Application No.: 10/500776  
Docket No.: CL1927USPCT

Amendments to Drawings

### **REMARKS**

FIG. 1

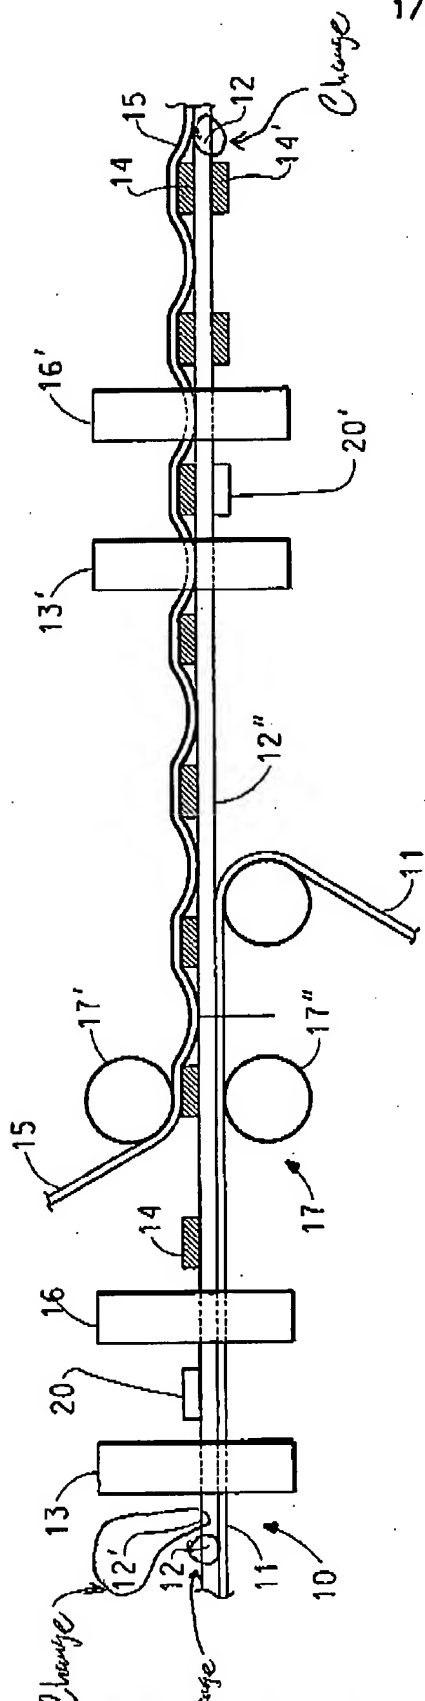
The Examiner objected to the drawing because the reference character "12" was used to designate both the polymer membrane and the first surface. The Examiner noted that in the specification, the first surface is designated 12'. Applicants note that the reference characters 12, 12' and 12'' are clearly shown in Figure 2 of the drawings. Applicants have amended Figure 1 of the drawings by extending the line extending from the reference character 12 (both instances) to more clearly show that reference character 12 is identifying the membrane, and Applicants have added the reference character 12' as already appeared in Figure 2. These changes are fully supported in the specification at page 14, lines 19-24 and in Figure 2 of the drawings.

Please amend Figure 1 as shown on the replacement sheet attached to this Amendment. An annotated copy of the replacement sheet showing the changes to Figure 1 is also attached to this Amendment.
